# Intel<sup>®</sup> Celeron<sup>®</sup> Processor Specification Update

Release Date: January 2002

Order Number: 243748-040

The Intel<sup>®</sup> Celeron<sup>®</sup> processor may contain design defects or errors known as errata, which may cause the product to deviate from published specifications. Current characterized errata are documented in this Specification Update.

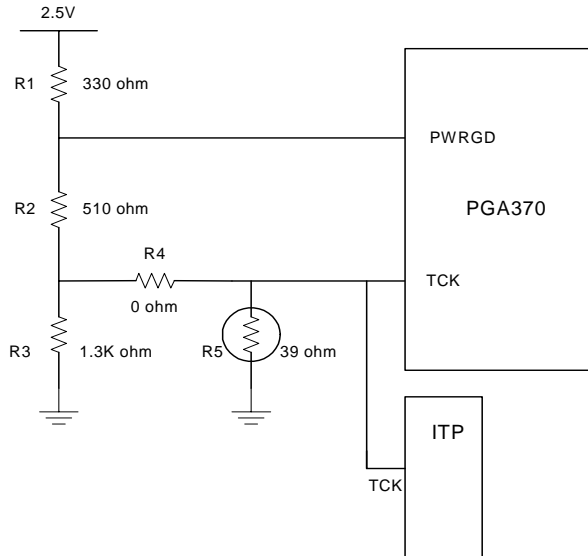
**Workaround:** To prevent the risk of power-on boot failures or catastrophic thermal failures, a platform workaround is required. The system must provide a rising edge on the TCK signal during the power-on sequence that meets all of the following requirements:

- Rising edge occurs after Vcc\_core is valid and stable
- Rising edge occurs before or at the de-assertion of RESET#
- Rising edge occurs after all Vref input signals are at valid voltage levels
- TCK input meets the Vih min and max spec as mentioned in EMTS

Specific workaround implementations may be platform specific. The following examples have been tested as acceptable workaround implementations.

Please note, the example workaround circuits attached require circuit modification for ITP tools to function correctly. These modifications must remove the workaround circuitry from the platform and may cause systems to fail to boot. Review the accompanying notes with each workaround for ITP modification details. If the system fails to boot when using ITP, issuing the ITP 'Reset Target' command on failing systems will reset the system and provide a sufficient rising edge on the TCK pin to ensure proper system boot.
